UNITED STATES PATENT AND TRADEMARK OFFICE

APPLICATION NO.	FILING DATE	FIRST NAMED INVENTOR	ATTORNEY DOCKET NO.	CONFIRMATION NO.	
10/698,638	10/31/2003	Rex Wesley Shores	31849.35	3375	
	7590 03/02/2007 D BOONE, LLP		· EXAMINER		
901 MAIN ST			CUMBERLEDGE, JERRY L		
SUITE 3100 DALLAS, TX 75202		ART UNIT	PAPER NUMBER		
,	•		3733		
SHORTENED STATUTOR	Y PERIOD OF RESPONSE	MAIL DATE	DELIVERY MODE		
3 MO	NTHS	03/02/2007	PAPER

DETAILED ACTION

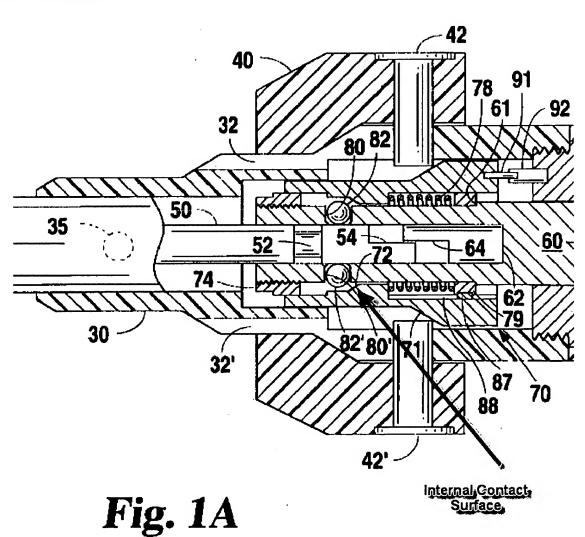
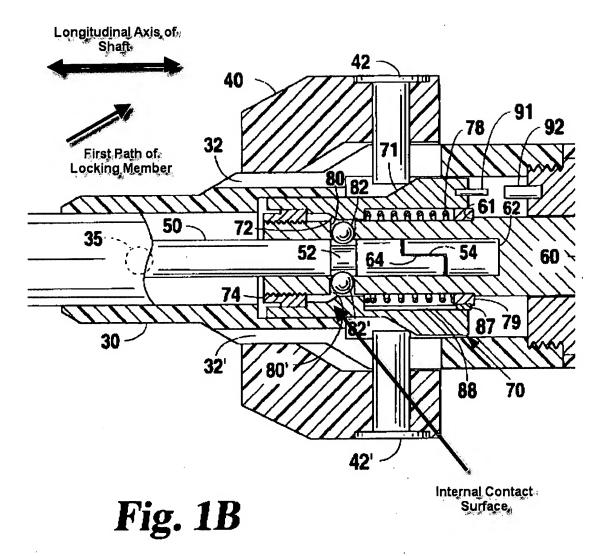
With regards to Applicant's argument that Mickel fails to teach a locking member movable through a first path in a direction at least partially parallel to said longitudinal axis in a locked position, the Examiner respectfully disagrees. The locking member (Fig.

1A, ref. 82) is movable through a first path (Figs. 1A and 1B, below, enlarged and truncated) in a direction at least partially parallel to said longitudinal axis in a locked position. Since the locking members must roll up the internal contact surface of ref. 72, they must move in the direction of the ramp, which is not transverse to the longitudinal axis of the shaft, but is at an angle with the shaft and therefore the first path is "partially parallel" to the shaft.
